COUNCIL REPORT

File No: DVP 21-08

Subject: **DVP 21-08, Development Variance Permit, 1885 Diamond View Drive**

Figure 1 - Proposed Setback Variances

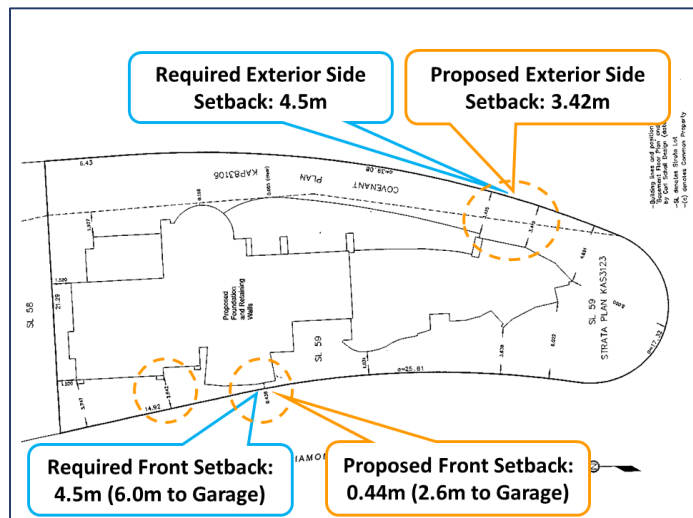
The proposed variances to reduce the required setbacks from the private access easement at the front of the proposed single detached dwelling are not anticipated to result in significant negative impacts. Diamond View Drive is a Strata Road, therefore any future road improvements would be completed by the Strata that this property is within.

While the distance from the garage to the property line is reduced to 2.64 m, there is an additional distance of approximately 3.4 m between the back of curb on Diamond View Drive and the property boundary (*Figure 4*). The private access easement restricts the parking of vehicles within the easement area and the proposed three car garage provides the required on-site parking for the dwelling.

Figure 3 - Proposed 4 storey (12.4m) Single Detached Dwelling

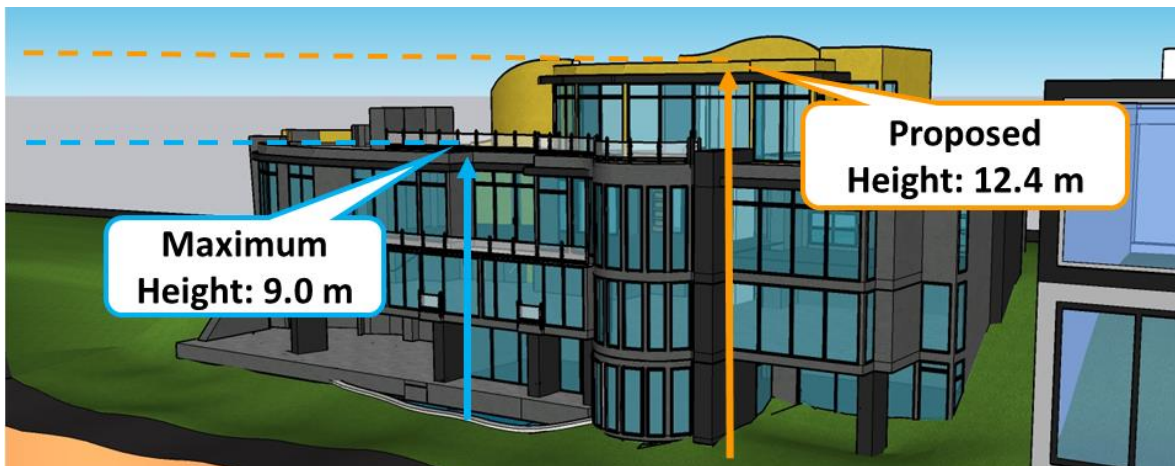
The proposed height variances are significant and have the potential to create negative impacts on surrounding property owners. Four storey structures are not permitted within the City's residential zones outside of Westbank Centre. Single detached, townhouse and apartment developments within neighbourhood areas are restricted to three storeys throughout the City.

A number of the City's guidelines for hillside development are not met by this proposal including moderating the building mass on steeper sites and stepping of the building with the natural slope. Building height and mass have not been limited to minimize visual impacts, and the building could be designed to both meet the Zoning Bylaw's height regulations and the OCP's guidelines for development on hillsides.

However, the height variance requests have the potential to create negative impacts to adjacent properties and it is not recommended that Council approve the requested height variances. The proposed building does not substantially meet the City's Guidelines for Hillside development and could be redesigned to integrate more sensitively into the neighbourhood. The applicant will be required to redesign the dwelling to meet the City's height regulations within the Zoning Bylaw.

Figure 6 - Existing Bank between Scott Crescent and Proposed Development

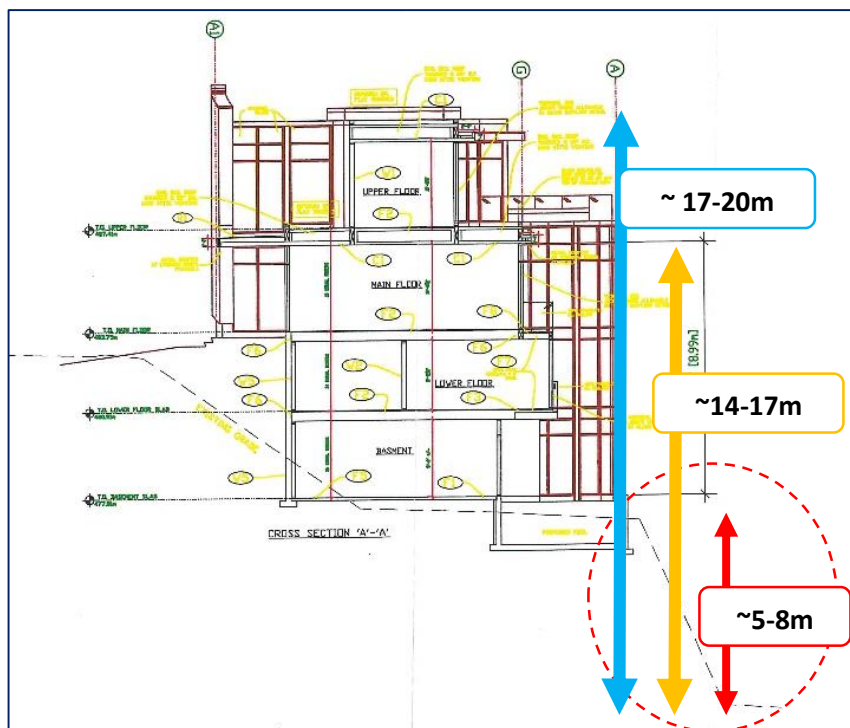
The proposed dwelling's increased height will be further exaggerated by the steep bank below the dwelling and above Scott Crescent (*Figures 5 and 6*). The bank above Scott Crescent ranges in height from approximately 5 m to 8 m long the property's frontage.

As the proposed development is proposed with no significant setback from the top of the bank due to the narrow lot width, this will further amplify the buildings height from Scott Crescent below, resulting in potential impacts to adjacent residents. The approximate height between the Scott Crescent and the top of the proposed building before it steps back would be between 14 m and 17 m (*Figure 6*).
